ADDENDUM #3

RE: RFP 21/27 CPS Nature School

TO BIDDING DOCUMENTS ENTITLED:
Columbia Public Schools
RFP 21/27 CPS Nature School

PWA PROJECT NUMBER: 201621.54
PWA PROJECT NAME: CPS NATURE SCHOOL COUNCIL HOUSE

DRAWING NO.
A105
Sheet 3 of 3

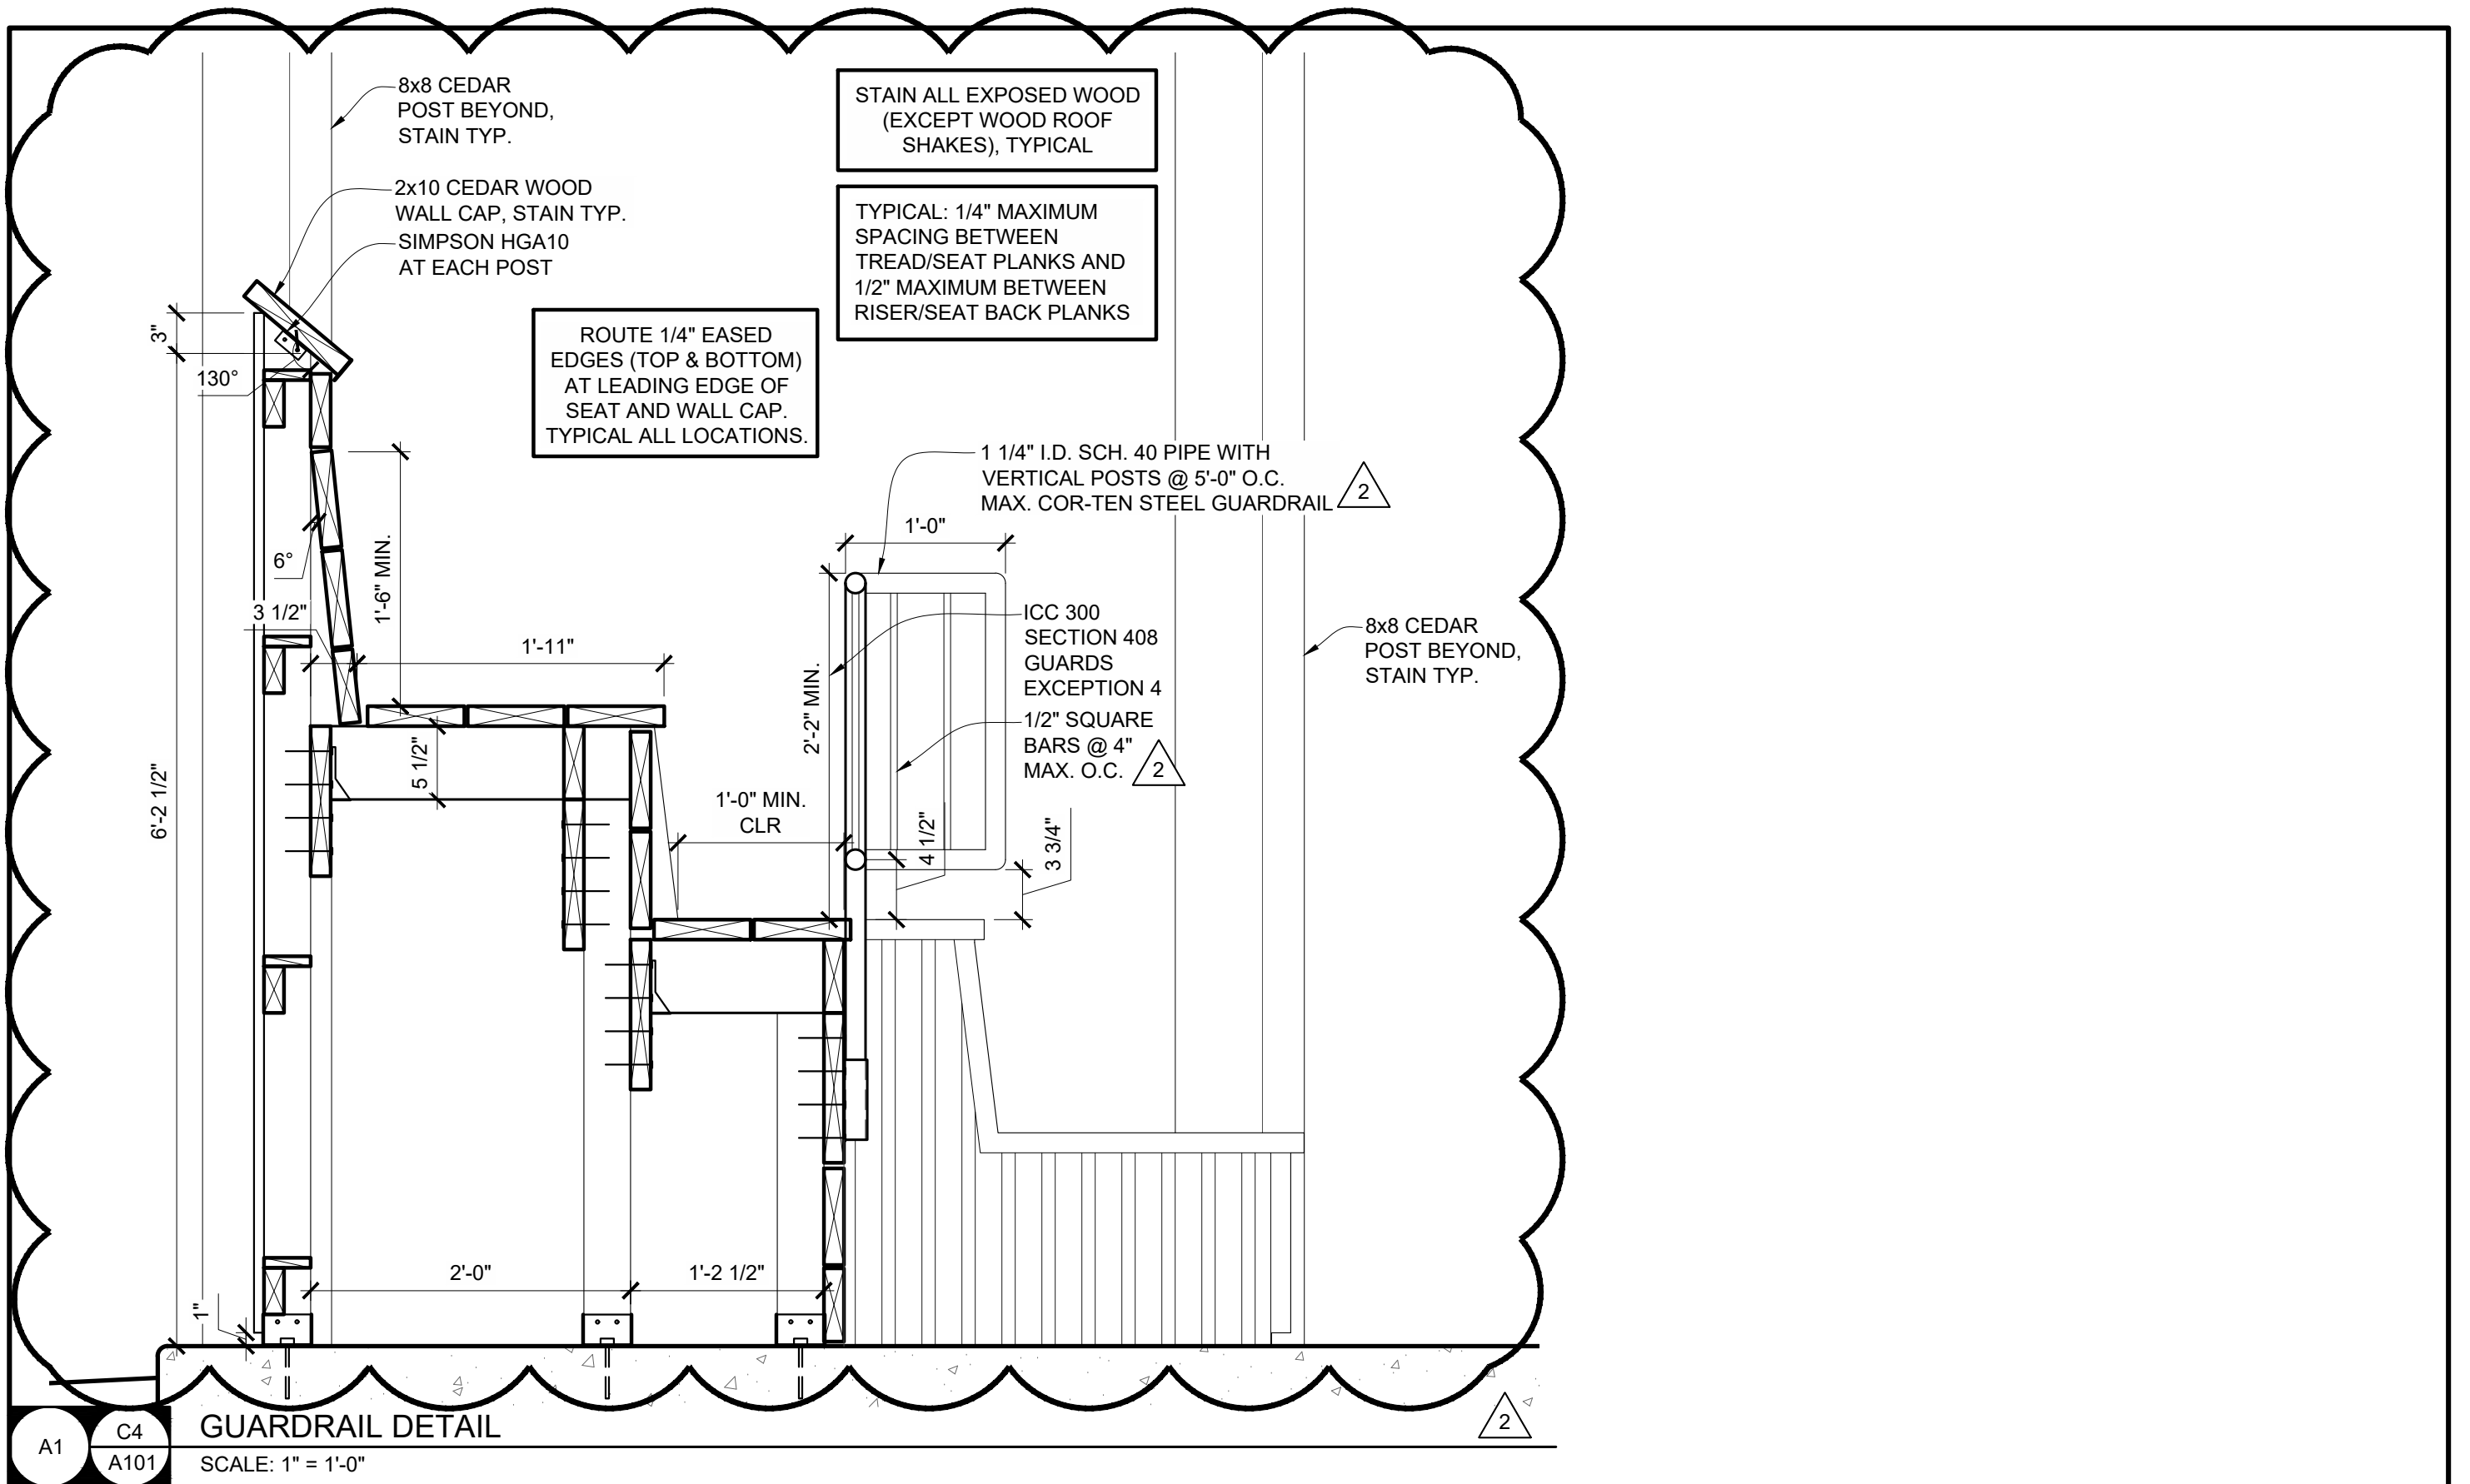
3. **Clarification, Detail A1 on Added Sheet A05 – Sections:**

Cor-ten steel guardrail shall be installed between the wheelchair space and the upper benches.
